File Ref: SSD-10468

New Request for Advice – Warehouse and Customer Fulfilment Centre, Marrickville

Property: 74 Edinburgh Road, Marrickville

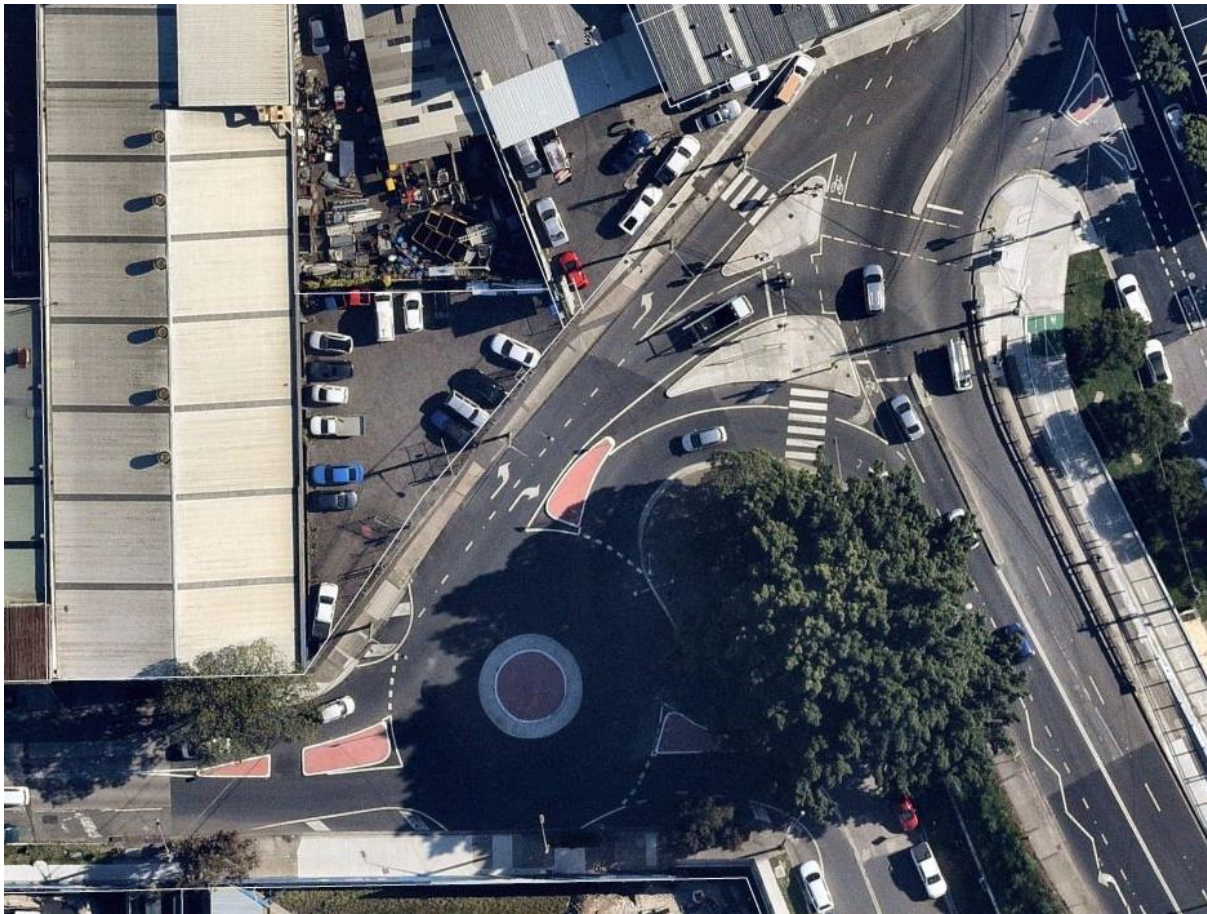
- i. The proposed relocation of the Sydney Water Stormwater channel to Council’s Road Reserve (new footpath alignment) is not supported. Removing the Stormwater channel from within the property to encumber Council property is unsatisfactory. Any relocation shall be undertaken within the final lot boundaries of the site.
- ii. The channel will be 3000m wide (assumed internal) and close the surface. No details on cover available over the channel have been provided. The width of the channel will take up the full width of the footpath leaving little room for existing and proposed services in the footpath. In addition due to the width and minimal cover over the channel no meaningful landscaping and trees can be planted. In addition, there will be no room for the relocation of services within the footpath. The existing footpath has Ausgrid power

cables and poles, Council stormwater pits and pipes, 150mm water main, Telstra and NBN cables etc. The proposed relocation of these services needs to be detailed on future submission.
